UNITED STATES PATENT AND TRADEMARK OFFICE

APPLICATION NO.	FILING DATE	FIRST NAMED INVENTOR	ATTORNEY DOCKET NO.	CONFIRMATION NO.
10/732,712	12/11/2003	Tieyu Zheng	P17132	2060
21186	7590	08/08/2006	EXAMINER	
SCHWEGMAN, LUNDBERG, WOESSNER & KLUTH, P.A. P.O. BOX 2938 MINNEAPOLIS, MN 55402			DUPUIS, DEREK L	
			ART UNIT	PAPER NUMBER
			2883

DETAILED ACTION

Fig. 15

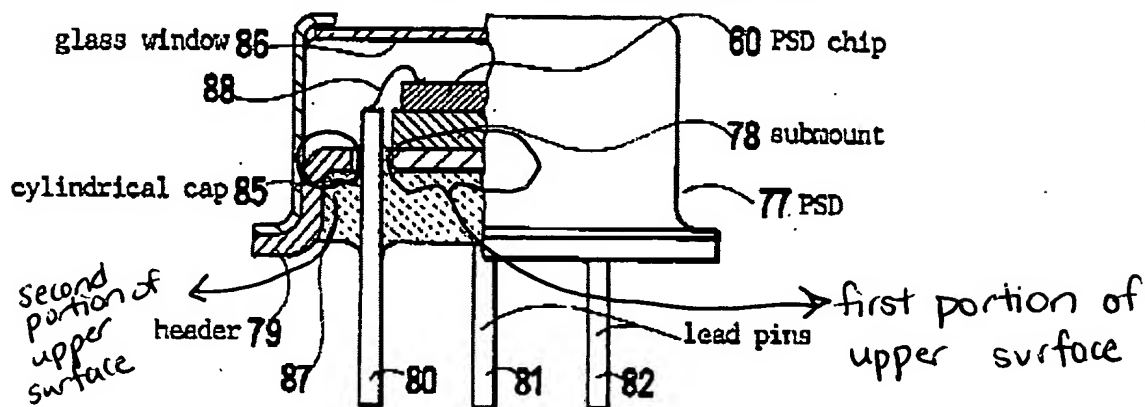
3. The examiner disagrees with this assertion. Paragraphs 7-10 of the non-final action mailed 3/10/2006 details how this structure is anticipated by Fujimura in view of Simon. Specifically, Fujimura teaches an optoelectronic device (60) mounted on a first portion of an upper surface of an insulating base (87); a metal sealing member (79) mounted to a second portion of the upper surface of the insulating base (79), the second portion surrounding the first portion; and a metal cap (85) coupled to the metal sealing member (79). The examiner has further identified the first portion and the second portions in the figure below to further explain how the reference reads on the claimed limitation. Note that this figure is a side-view. It is understood that elements such as the cap, sealing member, etc extend around the full perimeter of the device.

6. *Fujimura et al* teach a method of manufacturing a hermetically sealed optoelectronic package as seen in figure 15 having an optoelectronic device (60) mounted on a first portion of an upper surface of an insulating base (87). A metal sealing member of FeNi (79) is mounted on a second portion of the upper surface of the insulating base (87) so as to surround the first portion upon which the optoelectronic device (60) is mounted. A metal cap (85) is coupled to the metal sealing member (79). The method comprises the steps of supplying a force to push the

metal cap (85) against the metal sealing member. While Fujimura et al do not explicitly disclose a force, a force of some kind must inherently be applied to the metal cap to make contact with the metal sealing member to achieve the configuration shown in figure 15. See column 13, lines 40-67.
